## DEVELOPMENT REVIEW COMMITTEE (DRC) Site Plan Application

**Re: *Holiday Inn Ft. Lauderdale  
2100 S. Federal Highway  
Ft. Lauderdale, FL  
DRC Site Plan Submittal Project Narrative***

## **DEVELOPMENT REVIEW COMMITTEE (DRC) COMMENT REPORT**

Site Plan Level III Review: 142 Hotel Units and  
Parking Reduction

DATE: 01-12-16  
 PROJECT NO: 15-063  
 DRAWING NAME:  
 GROUND FLOOR  
 SHEET NO:  
**A-1.1**

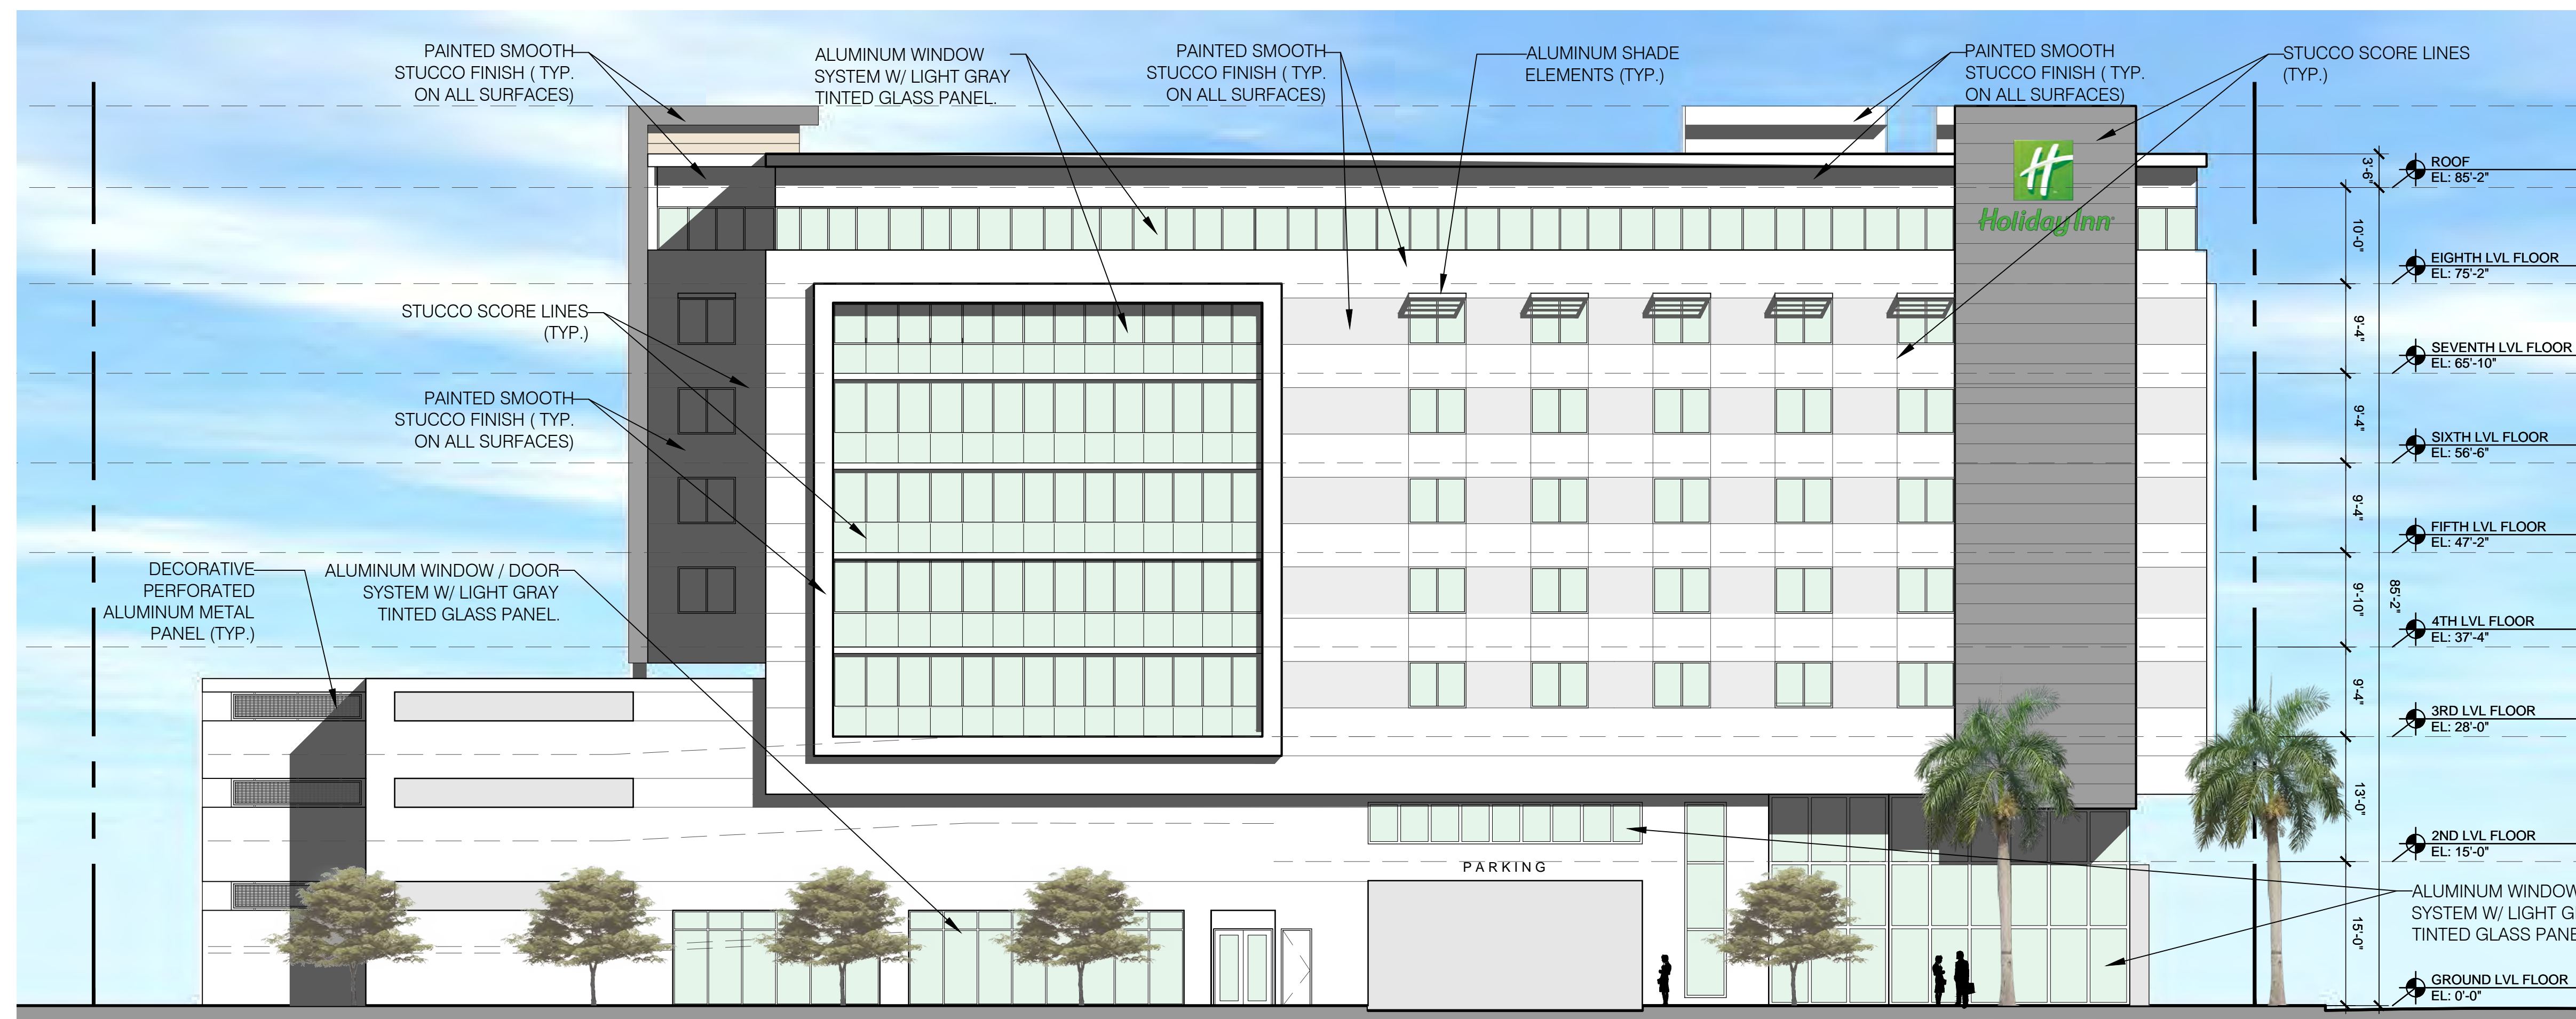
15. Sheet A-1.1: Stripe out as appropriate the Back of House area in the center of the parking garage that appears to be fenced.
16. Sheet A-1.1: Provide vehicle turning template for access into loading zone in alleyway.

18. Sheet A-1.1: Show on Site Plan that the loading area can accommodate the appropriate service vehicle. The narrative shall also include, but not be limited to, descriptions of the following: loading activities (including locations, times, and duration), hours of operation, trash disposal, security/gating, number of employees, etc.

- 7) Provide the following changes to the site plan:
- a. Line the garage ground floor with active uses along SE 21<sup>st</sup> Street and;
  - b. Explore options to activate ground floor facing the alley;

- c. Relocate the retail space at the South West corner of the building and relocate the Media Lounge Area at the second floor;
  - d. Provide a one way in and one way out driveway access/exit from the garage and reduce the curb cuts to maximum 14 Feet;

- e. Relocate the back of house space (B.O.H.) from the South West corner of the property and internalize it within the ground floor plan;
  - f. Relocate the bicycle parking to the South along the Alley;

**NORTH ELEVATION**

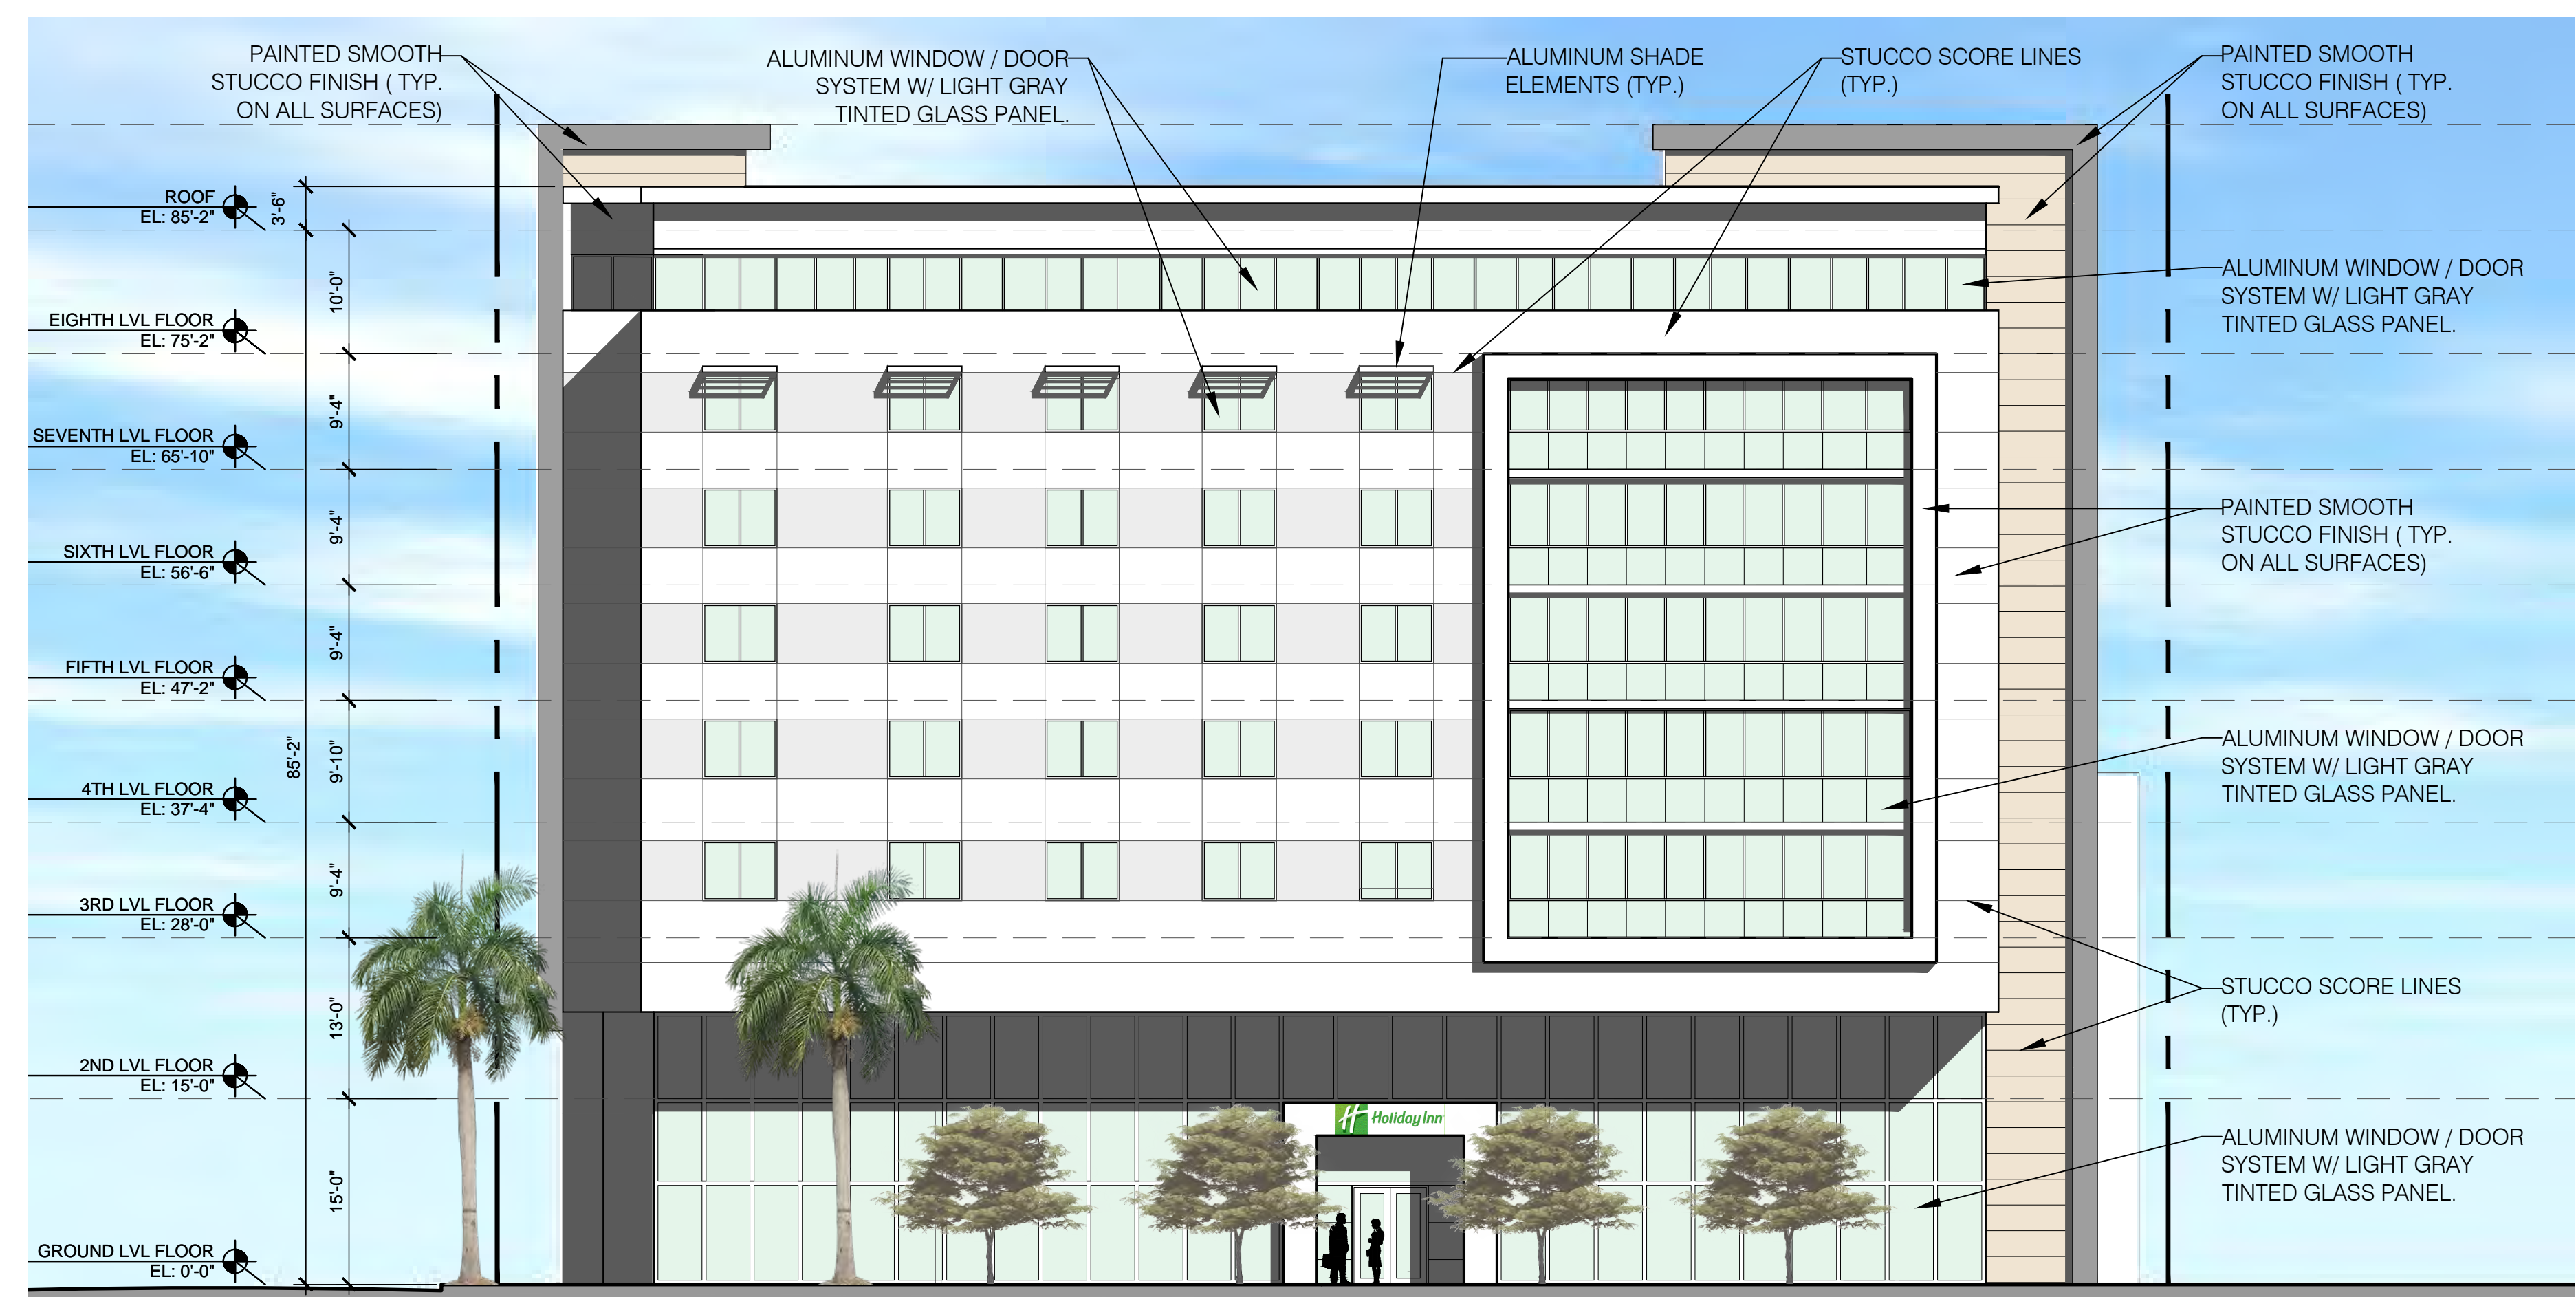
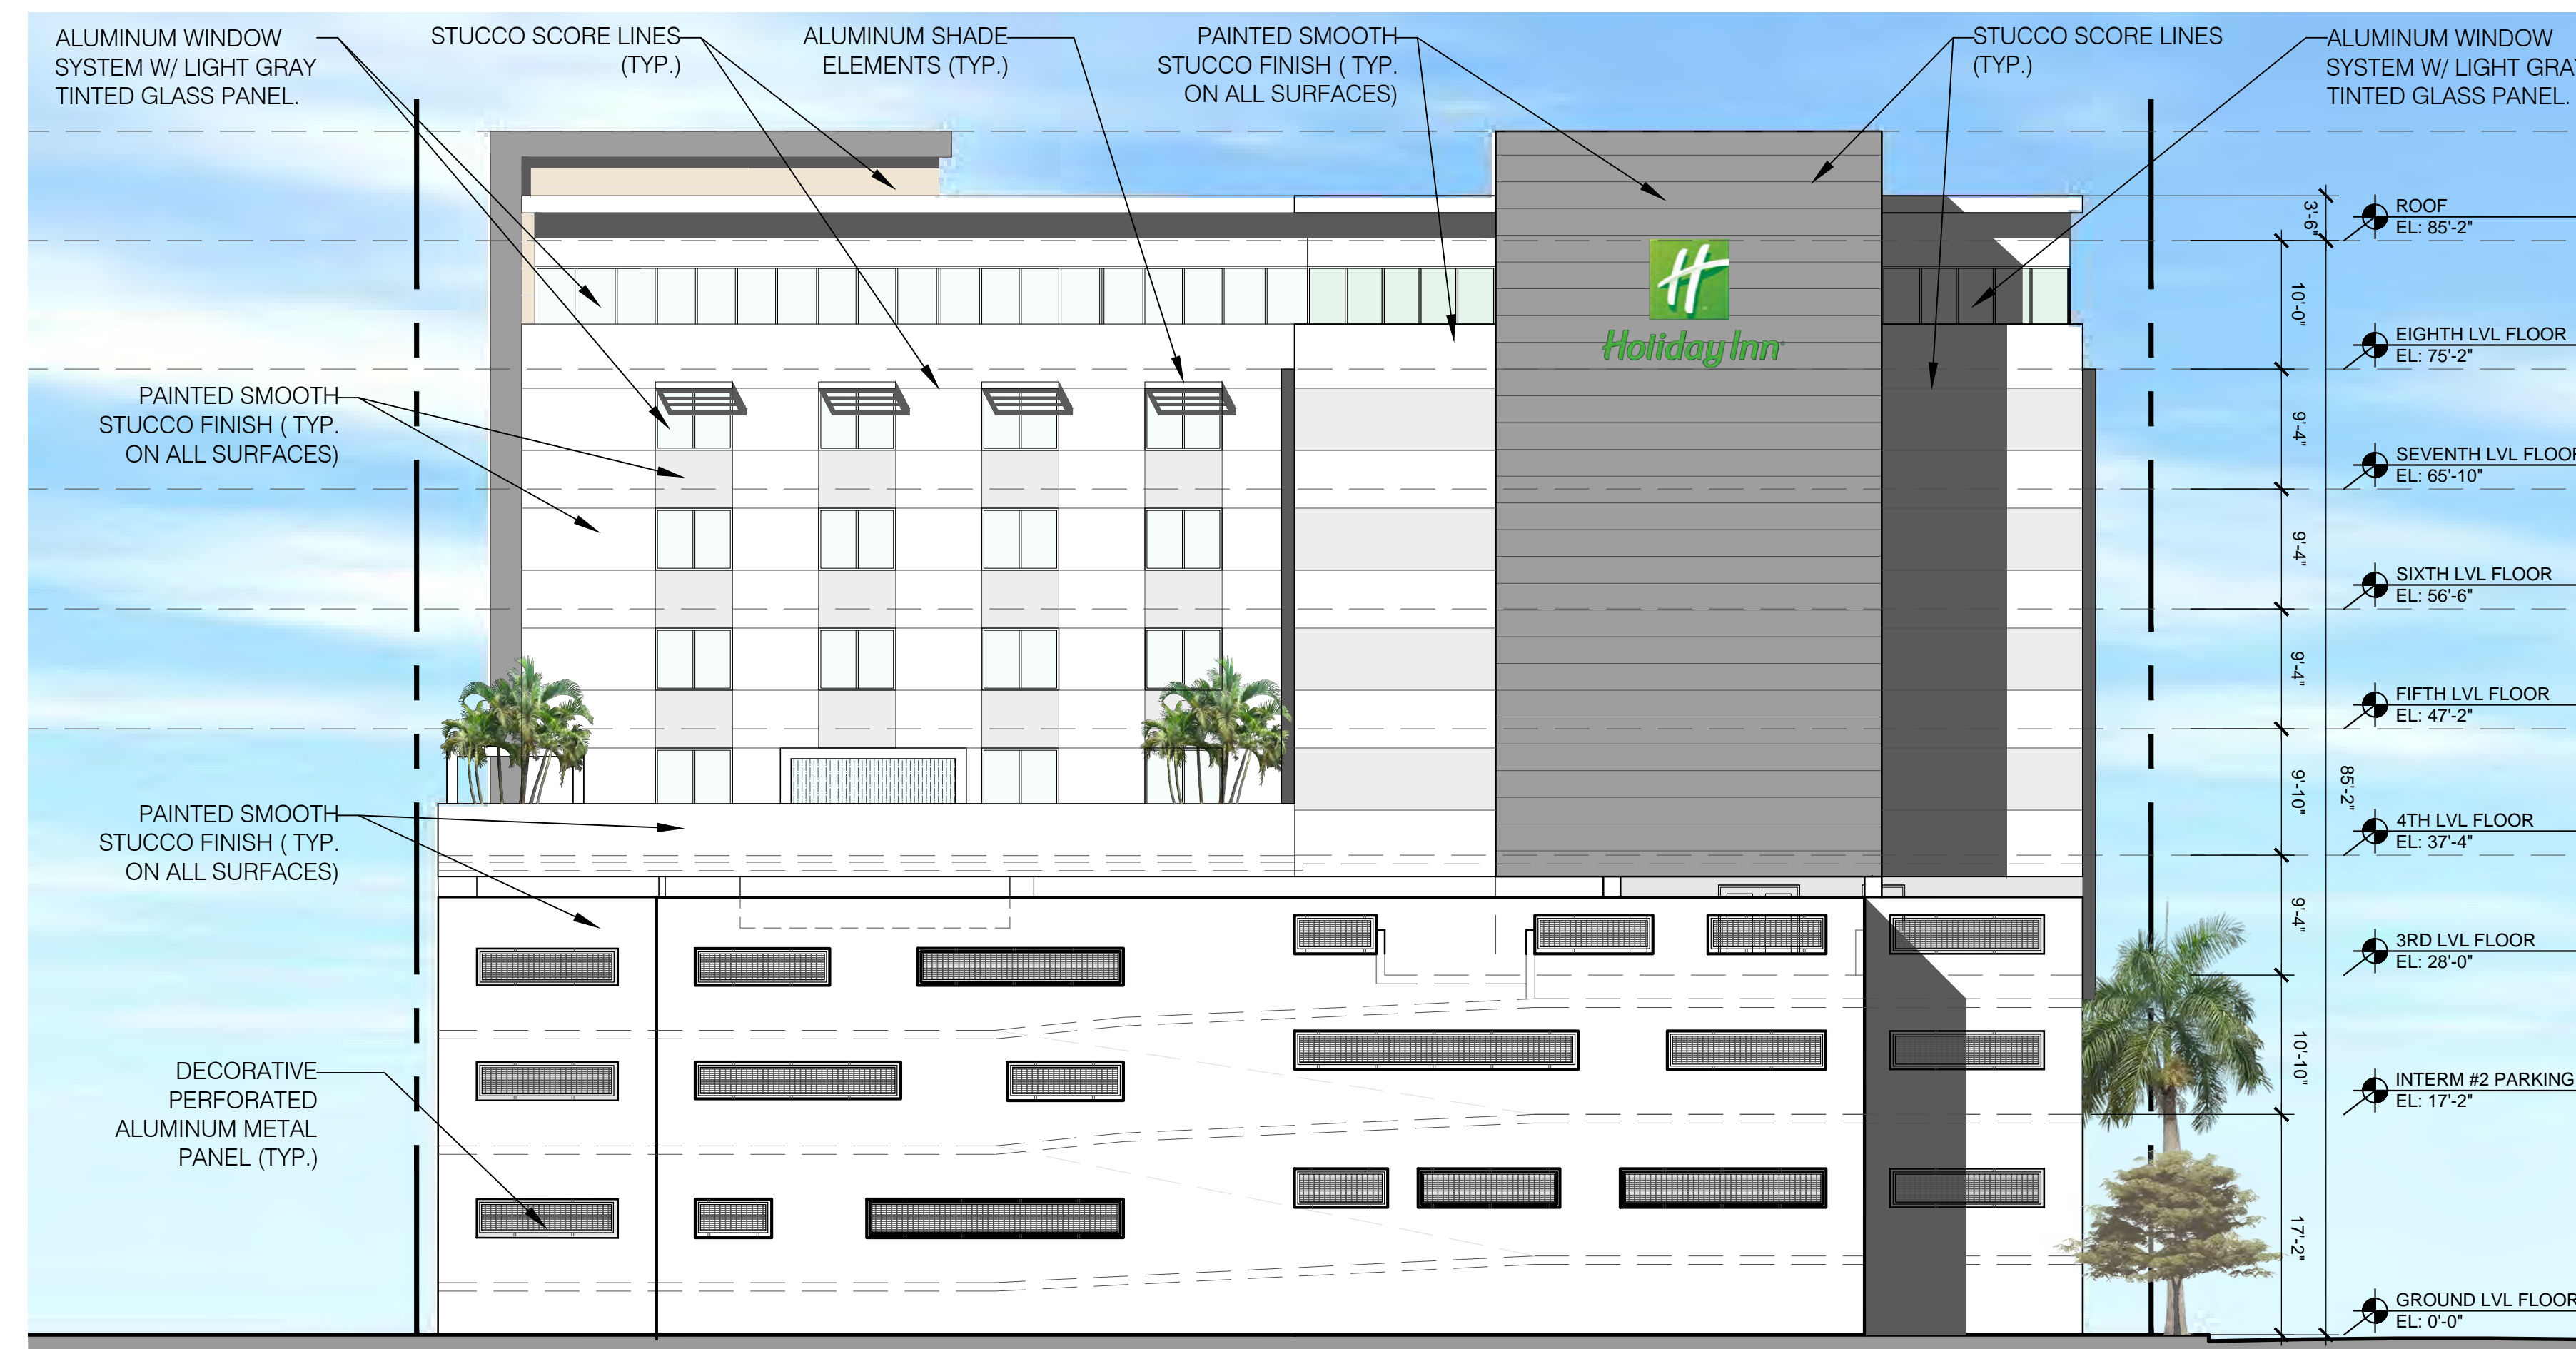
- l. Provide dimensions in the South and North elevations to demonstrate that the building meets the setbacks required based on Neighborhood Compatibility Criteria;
